Re: Proposal – Supplement RIWP – NEST BCP Project C932183

> PROPOSED SAMPLE LOCATIONS SUPPLEMENTAL RIWP NEST BCP PROJECT C932183

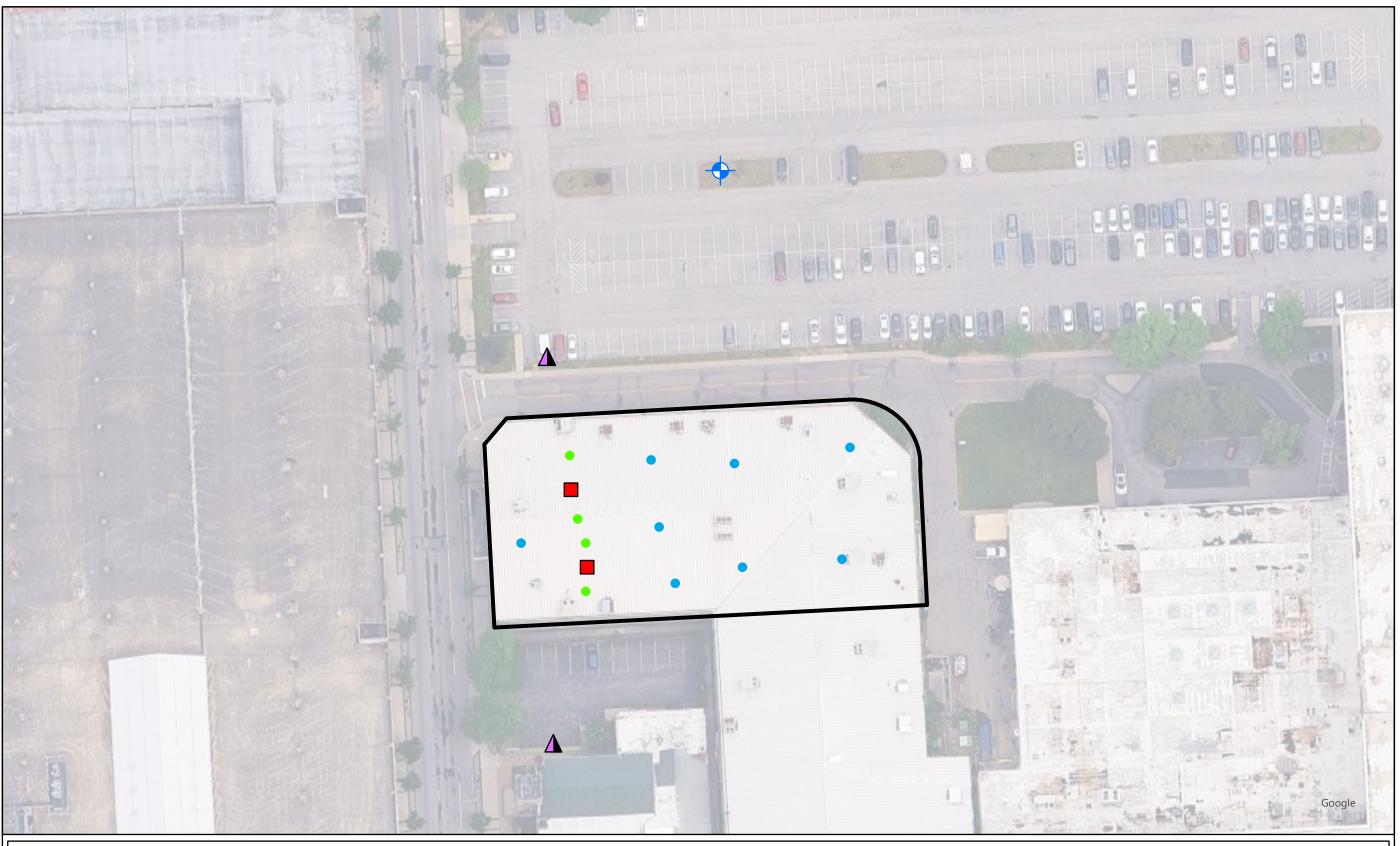
This proposal is to address comments regarding the Remedial Investigation for the Nest BCP Project. DEC and DOH are requesting these additional samples after reviewing the RI results and concluding that a decision of Significant Threat cannot be determined because of the unknown source location and migration pathway of the VOCs found in soil vapor and groundwater. A dry cleaner was formerly operating out of what is currently the northern parking lot located off-site. To fulfil the requirement of the Qualitative Exposure Assessment, the required additional data is needed to determine if this area is a potential source of contaminants migrating through the site and onto neighboring occupied properties. After collecting these samples, the DEC and DOH should be able to determine if the site is or is not a Significant Threat, then a Decision Document can be finalized and issued.

- 1. One offsite GW well will be installed at the attached location to the north of the project site. This well is anticipated to also be a bedrock well based upon local subsurface conditions. As such, installation will follow the previously approved RIWP Section 4.3 and associated procedures with a steel casing approximately 2' into bedrock. Based on information obtained during the RIWP, this well will be installed to a depth of approximately 30 feet bgs using core drilling. A Core log will be generated and submitted to the DEC for review. Analysis of the GW will include TCL VOCs, SVOCs, and PFAS.

- 2. Two proximate vapor points will be installed at the attached locations to the north immediately adjacent to the parking lot and to the south immediately adjacent to the church. These points are anticipated to be installed similarly to previous vapor points and will follow previously approved RIWP Section 4.4 and associated procedures with proposed depths of approximately 5 feet bgs (or 1 foot above bedrock whichever is shallower) equivalent to foundation depths.

- Four on-site soil samples will be collected beneath the concrete slab proximate to the 2 floor drains. These samples will be analyzed for TCL VOCs, SVOCs, and metals. Twelve on-site soil samples will be collected beneath the concrete slab at the locations indicated

on the **attached figure**. These samples will be analyzed for the recipient facility waste acceptance criteria. All sixteen soil samples will be collected after removing small areas of concrete via the excavator with appropriate attachment. All concrete will be placed back into the area from which it was removed after soil sampling. All soil will be sampled using procedures outlined in the previously approved RIWP.
